Outline of Inadequacies of Mr. Lee's Current Application

**MASTER MAP
OUTLINING
CONCERNS
AND
INADEQUACIES
OF MINING
APPLICATION**

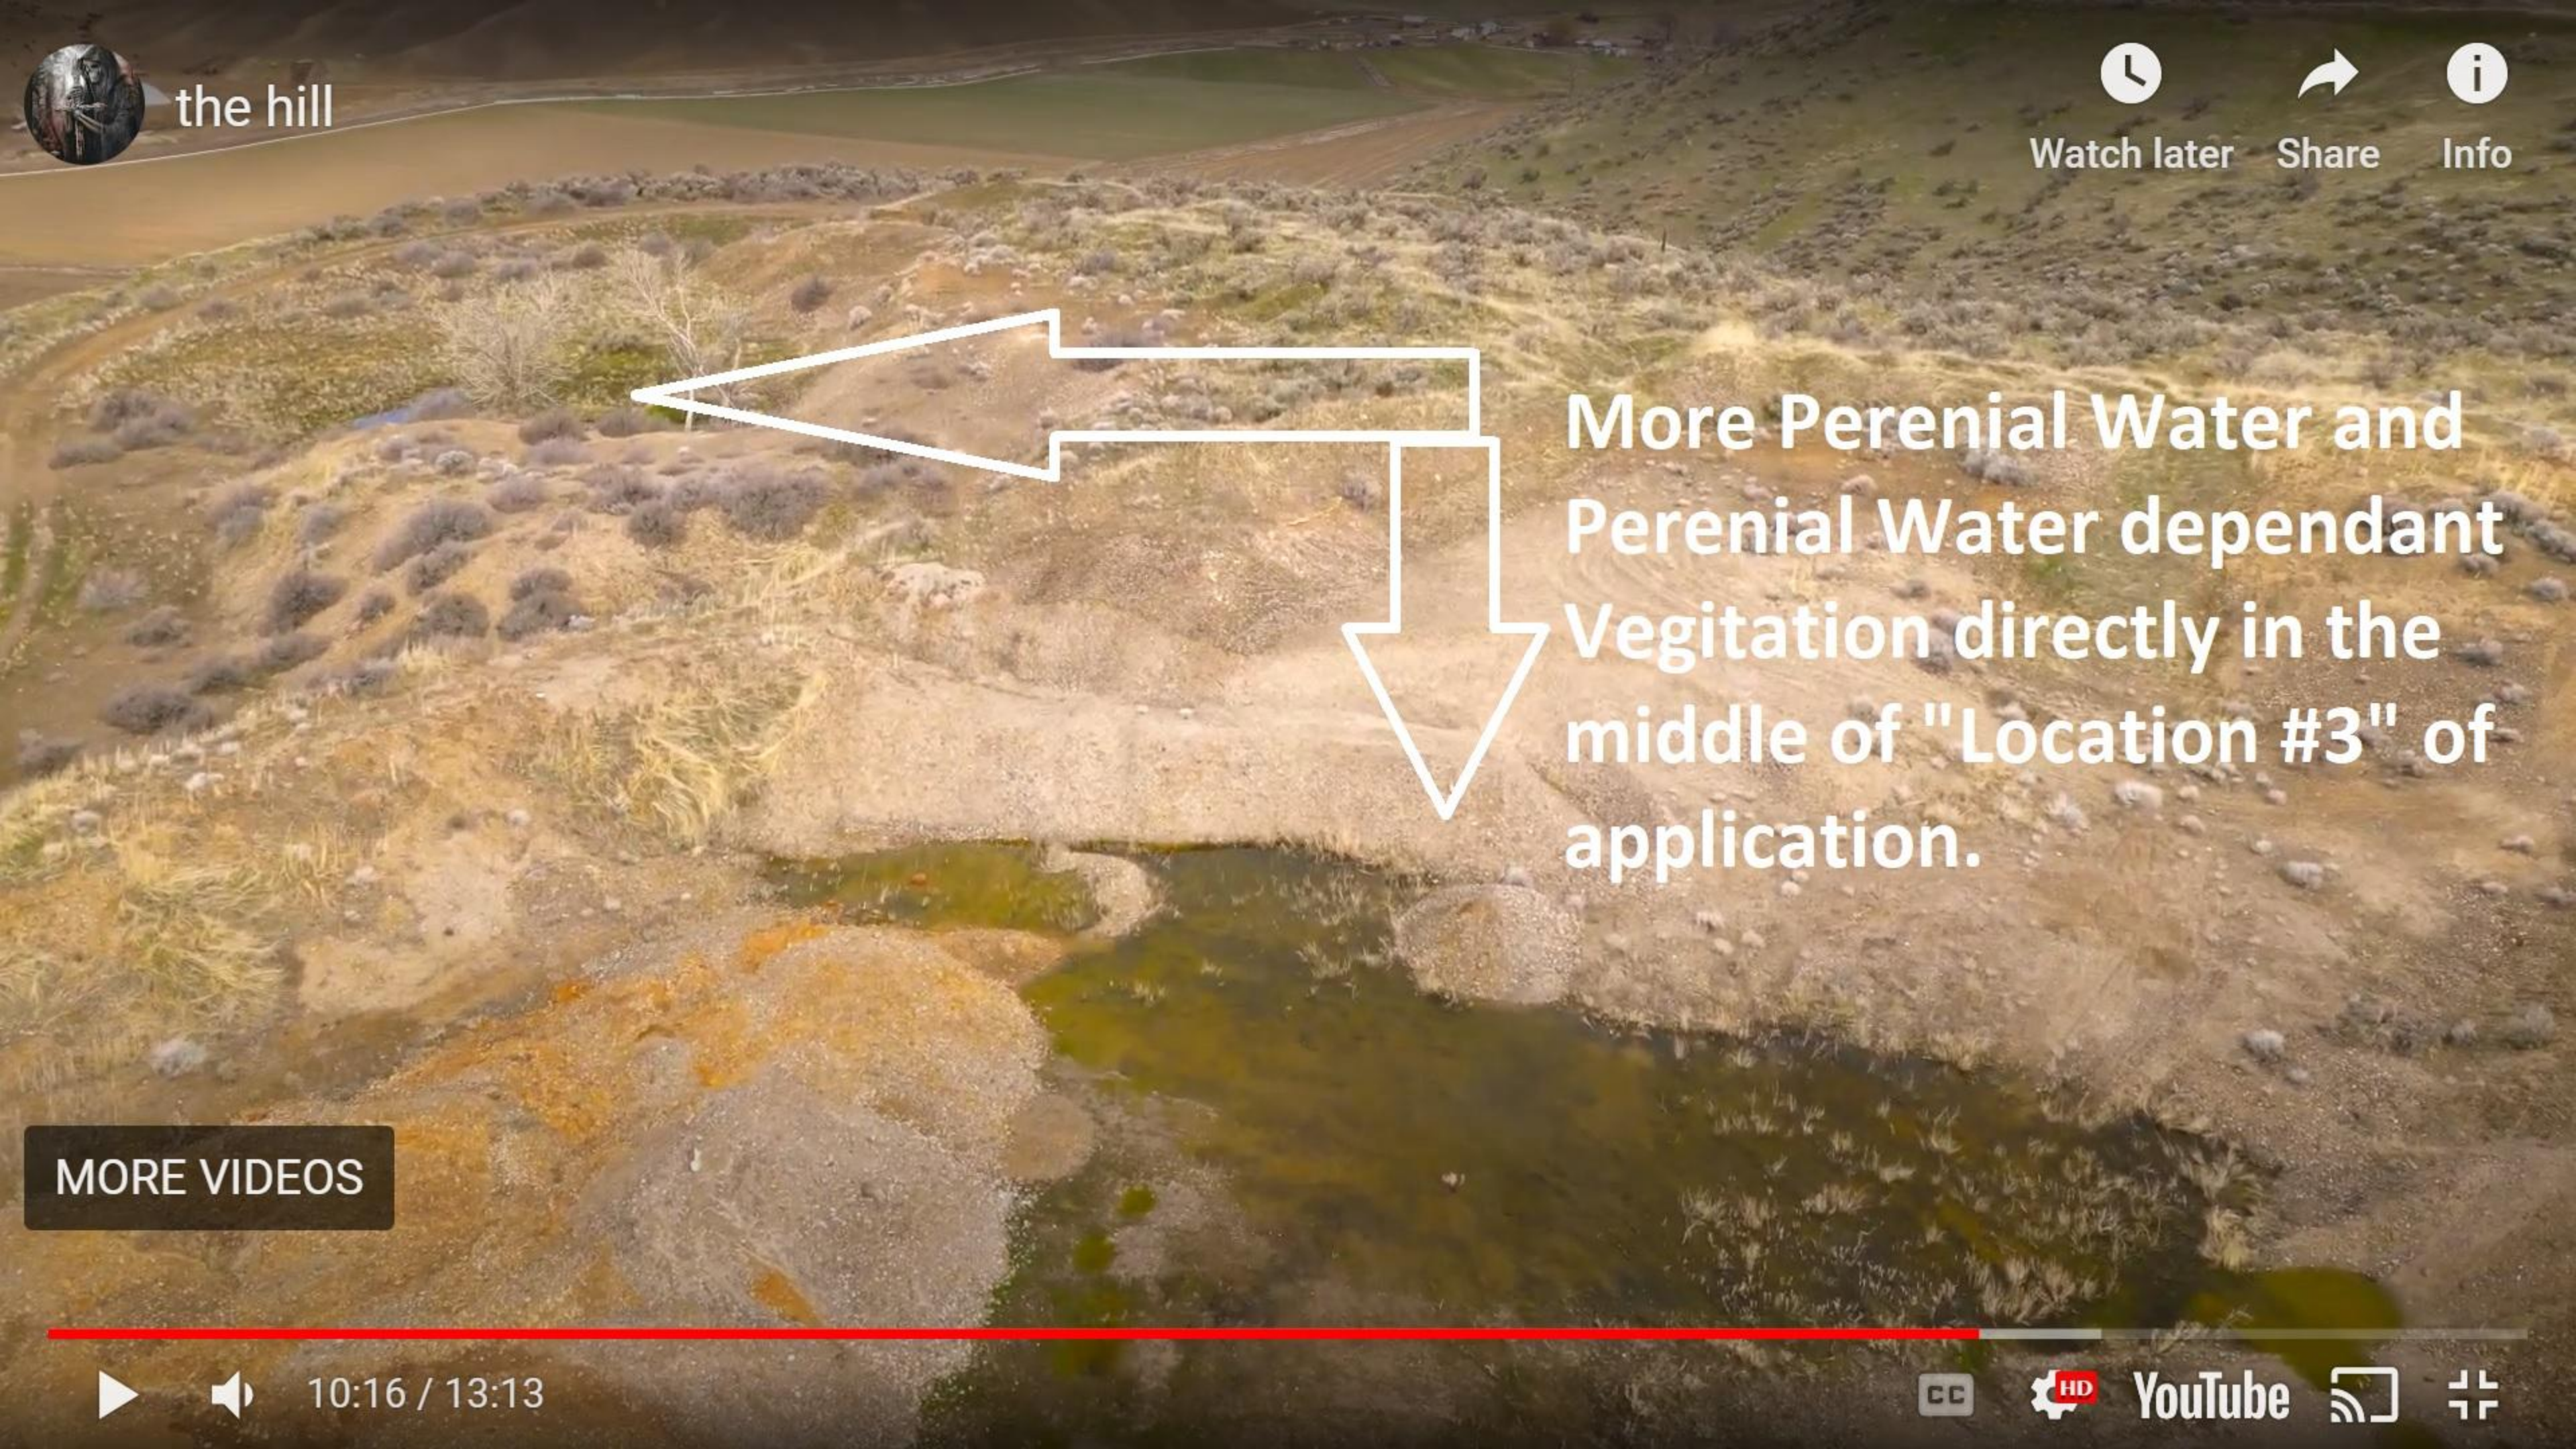
Home with residential well in the direct drainage path of the perennial wetland

Perennial Water with Ducks directly in the middle of "Location #3" in the application
